2011SYE034 – 321-327A Woolooware Road, Burraneer DA11/0218

ASSESSMENT REPORT APPENDICES

Pre-Application Discussion No. PAD10/0100

Re: Submission of Amended Driveway Plan

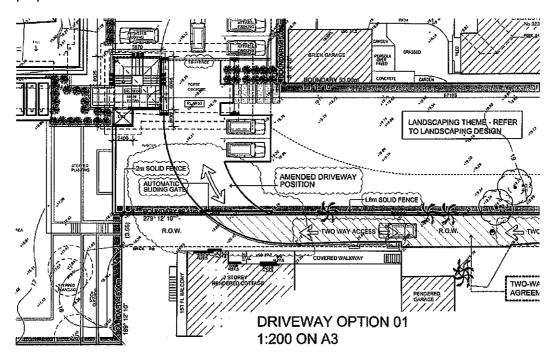
The access to the southern driveway will be two way (as is currently used by the residents at No 327a) rather than one way (as originally proposed); and

Attachment B - Amended Driveway Plan

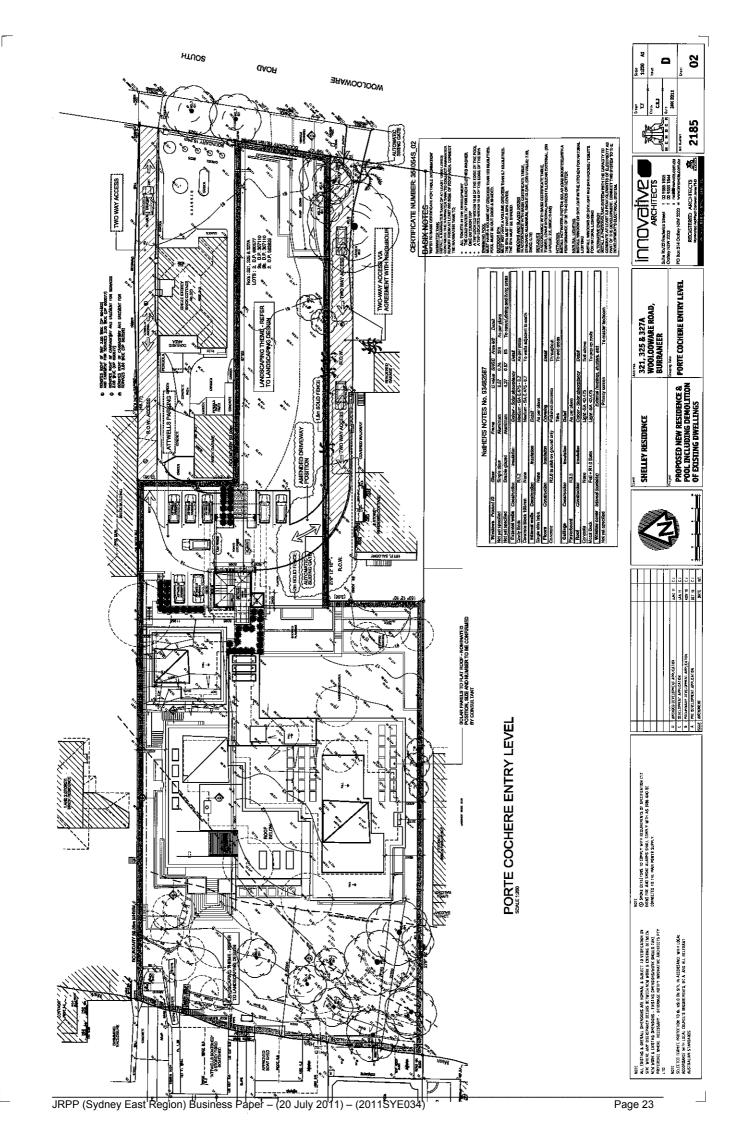
Amended plans are submitted with this letter to (a) provide a fixed fence between the Atwells car park and the porte cochere area (b) make the driveway 2 way and (c) change the corner design slightly. The changes are explained below:

Introduce a fixed fence between the Attwels car park and the southern driveway and porte cochere to prevent cars crossing from one area to the other.

The driveway has been curved slightly where it intersects with the southern ROC over No 327. This will ensure that headlights from exiting cars do not provide nuisance to the adjoining dwelling to the south at no 327 Woolooware Road.
